Product / Process Change Notification (PCN)
Honeywell Juarez Optoelectronica

PCN #	0171	Notification Date:	4/29/21
-------	------	--------------------	---------

Title:	Product Change Notification for change of temporary packaging box]		
--------	--	--	--

The next pictures show Packaging proposal #1

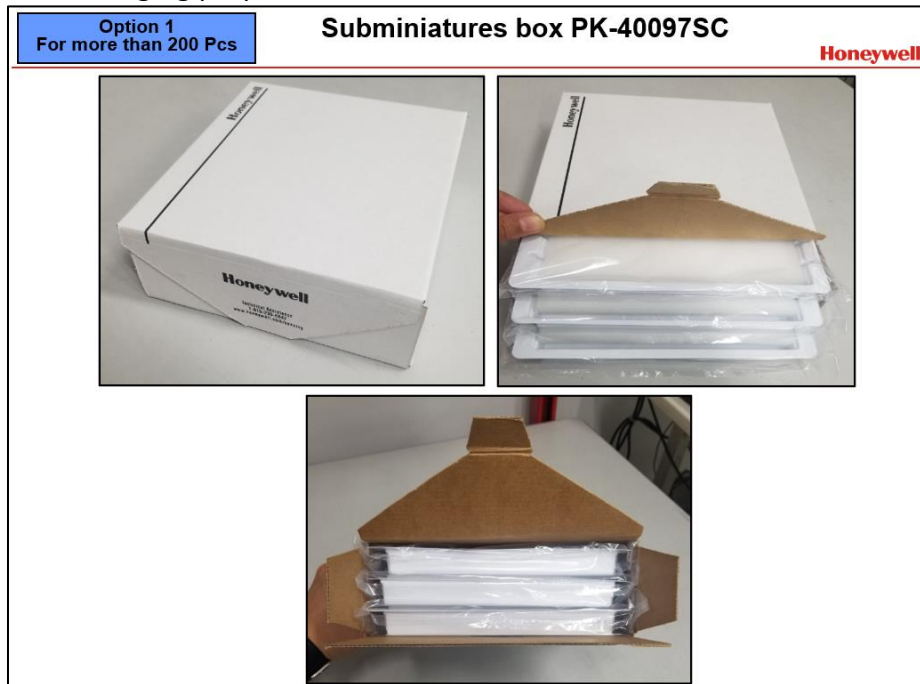
[Due to material shortage of box PK40095SC, from April 2021 to July 2021, temporary use of box PK-40097SC, which we currently use for switches with leva. Will returned to normal packaging tentative by the end of May 2021]

[Box general measurements will change from 7 3/4" X 13/16" X 8 7/16" to 7 13/16" X 2 5/8" X 8 3/8", pieces are protected and immobilized with a foam upon each tray and perfectly fit in a thicker box.]
